Addendum 3
TFM-029-26 – TA-511-25 ACADEMIC TUNNELS RE-WATERPROOFING CP-1

- .2 The Date of the Addendum is Friday, May 01, 2026

ACADEMIC TUNNELS RE-WATERPROOFING

TA-511-25

PROJECT No.	DRAWING No.
TA-511-25	C-2.7

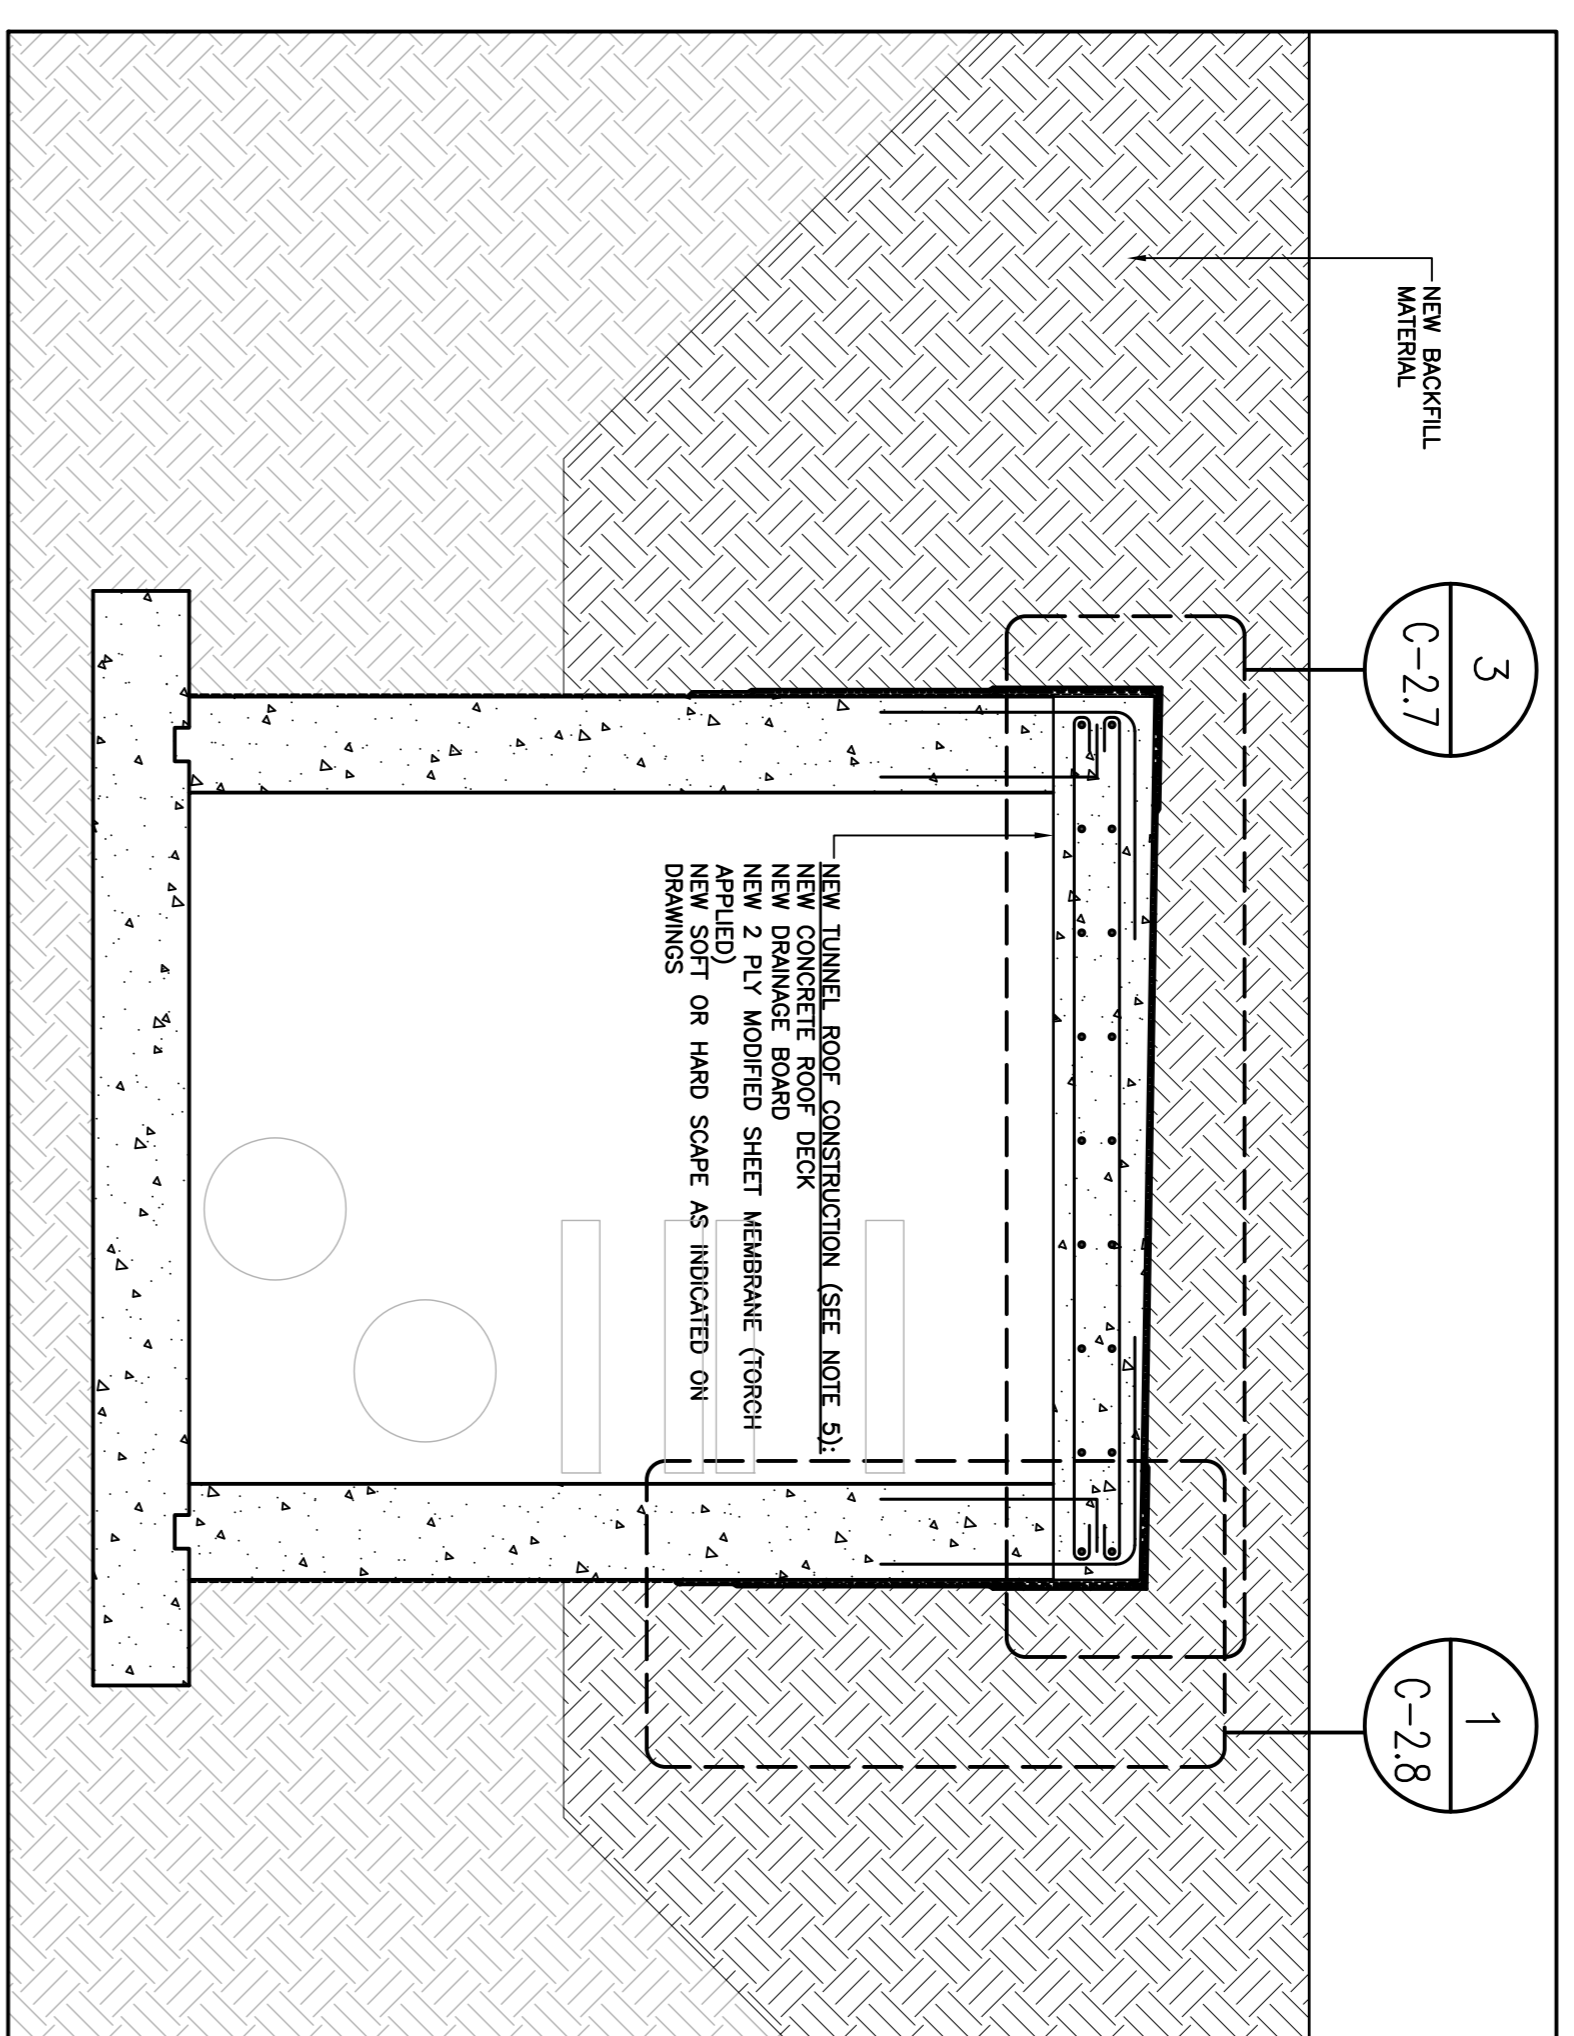
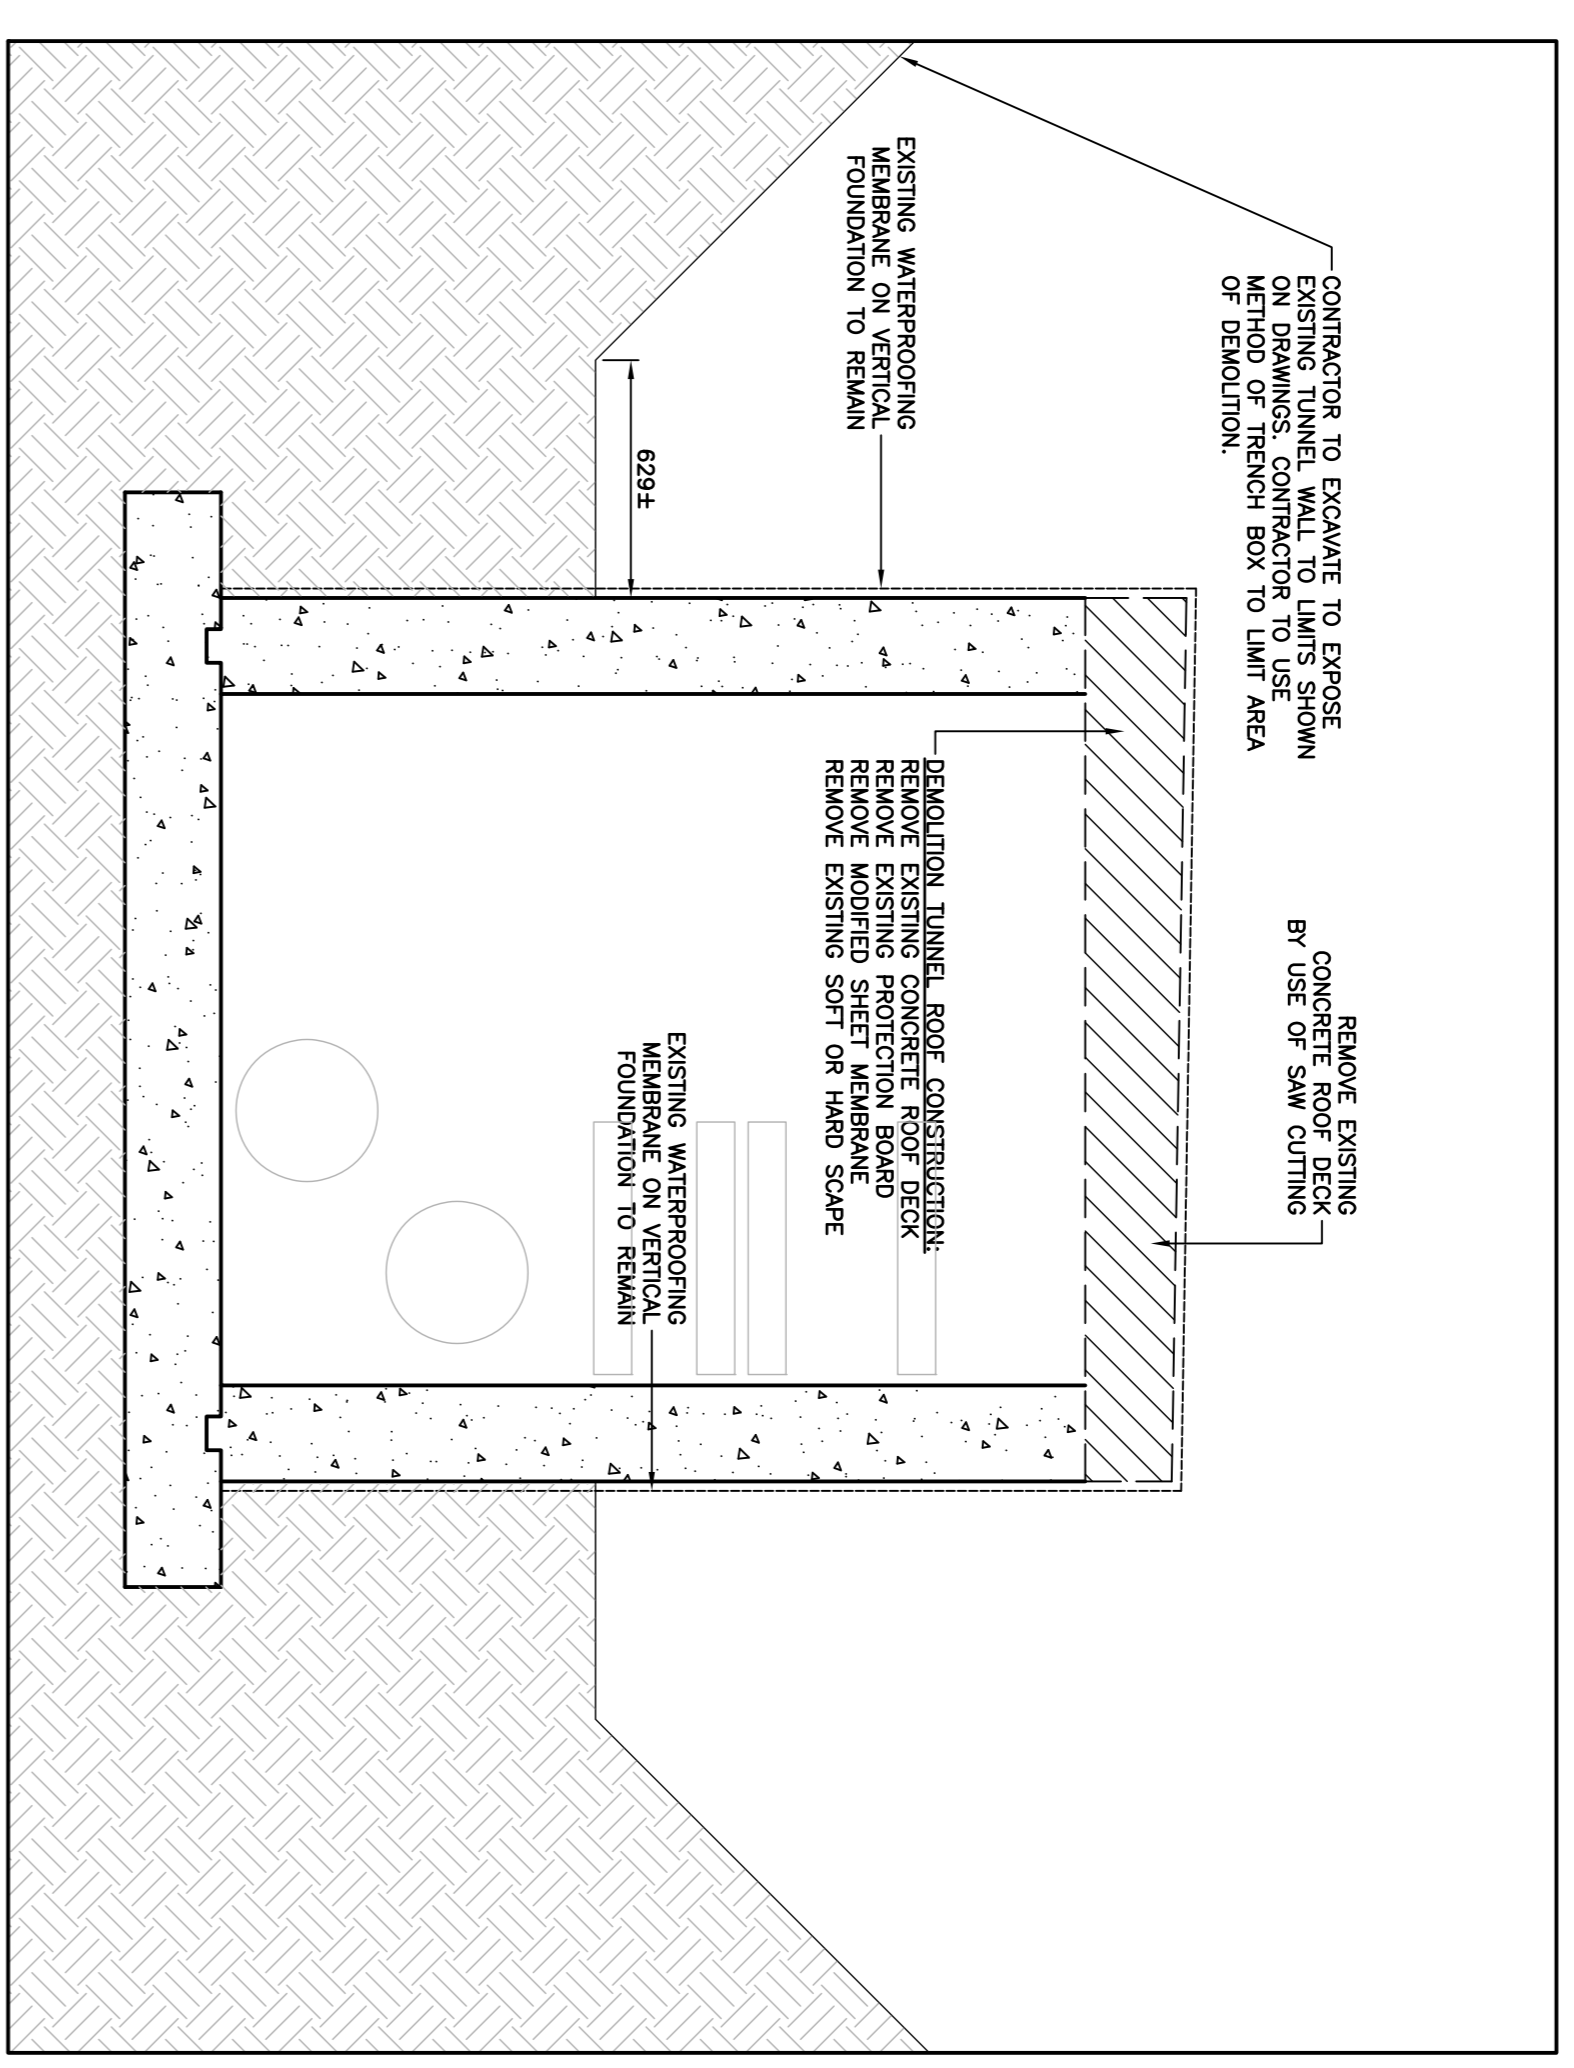
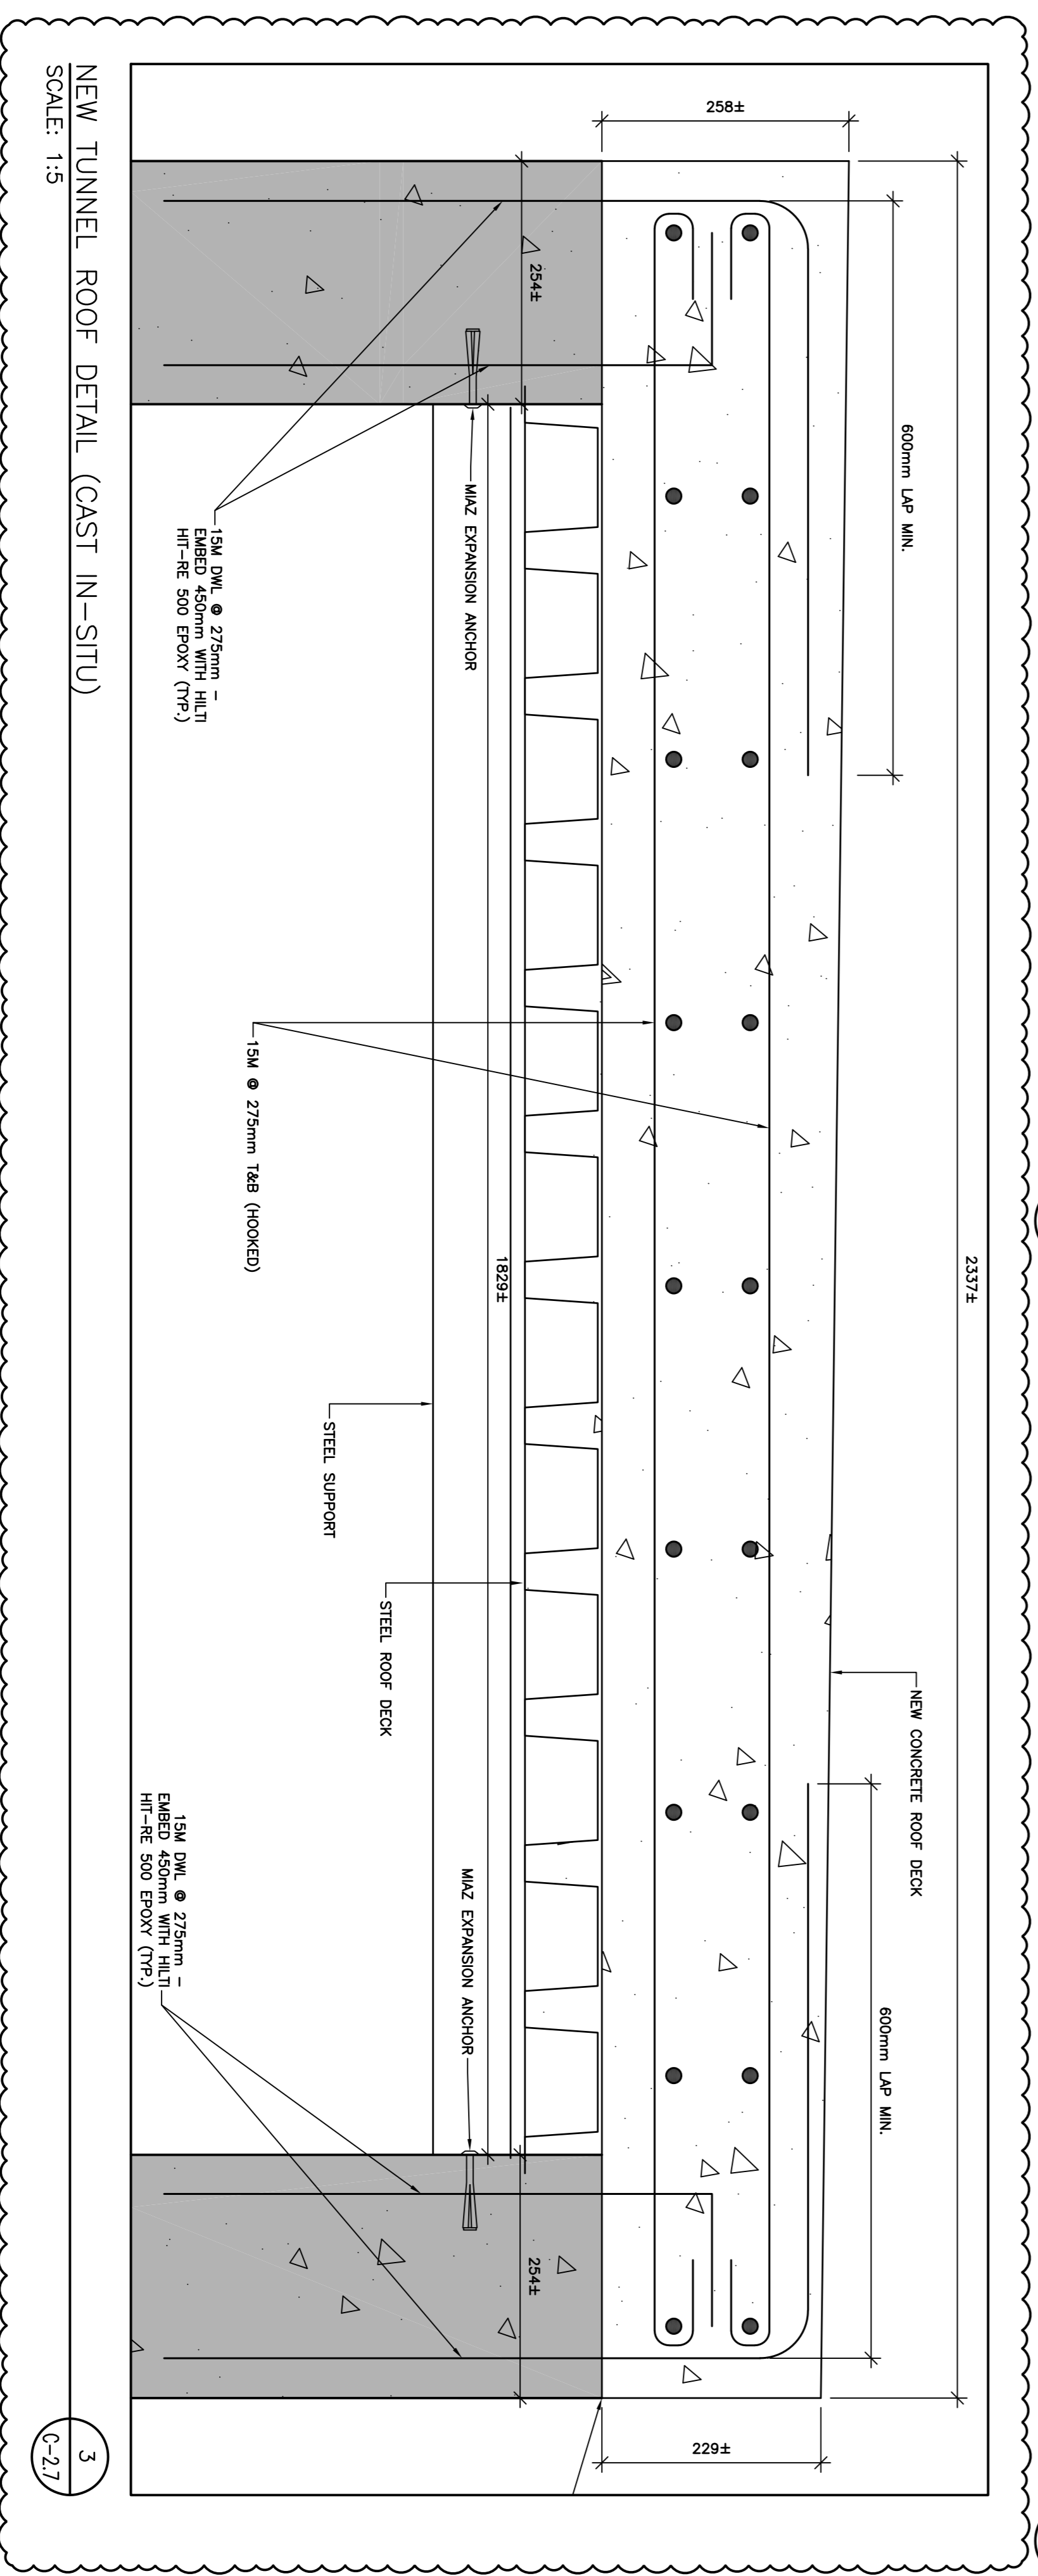
1. **Replace** drawing Cover Page (attached).
2. **Replace** drawing C-1.0 R3 with C-1.0 R4 (attached)
3. **Replace** drawing C-1.4 R0 with C-1.4 R1 (attached)
4. **Replace** drawing C-2.7 R0 with C-2.7 R1 (attached)
5. **Replace** drawing C-2.8 R0 with C-2.8 R1 (attached)
6. **Add** drawing C-2.9 R0 (attached)
